UNITED STATES PATENT AND TRADEMARK OFFICE

APPLICATION NO.	FILING DATE	FIRST NAMED INVENTOR	ATTORNEY DOCKET NO.	CONFIRMATION NO.
09/582,634	09/13/2000	Shirwan Alpasha Al Bahdaini		5682

Office Action Summary	Application No. 09/582,634	Applicant(s) AL BAHDAINI, SHIRWAN ALPASHA	
	Examiner Thai-Ba Trieu	Art Unit 3748

DETAILED ACTION

Projectile motion

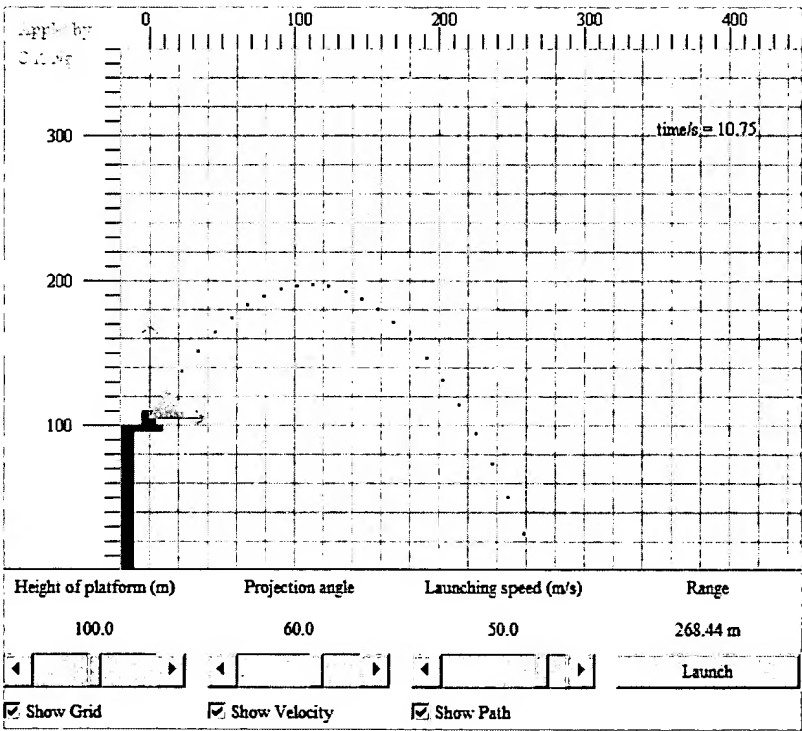
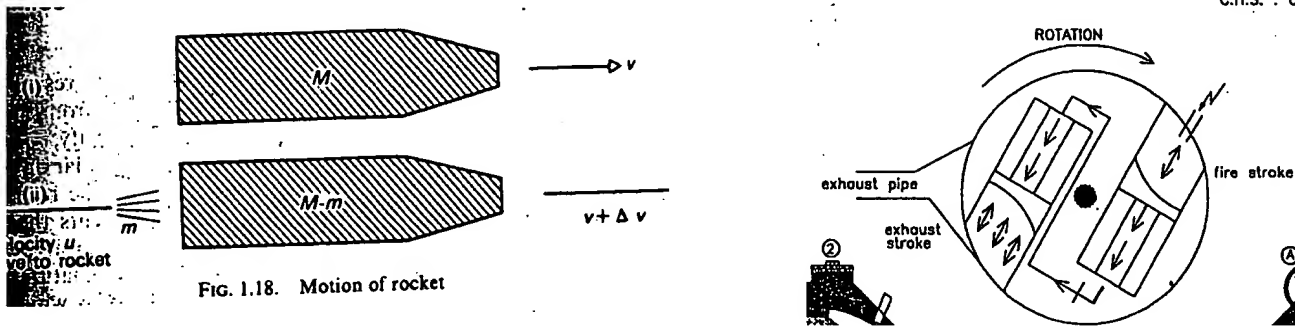
Examiner respectfully disagrees with the applicant, since the applicant has applied the concept of using a black powder explosion for guns to throw projectile bodies in explaining the rotation movement of the flywheel with substituting the projectile body by an elastic traveling piston to allow gases to expand or partially released causing impulse. How can a projectile movement of a body be related to the rotational movement of a flywheel/rotor? By the definition, projectile motion

refers to the motion of an object projected into the air at an angle. A few examples of this include a soccer ball begin kicked, a baseball begin thrown, or an athlete long jumping. Even fireworks and water fountains are examples of projectile motion.
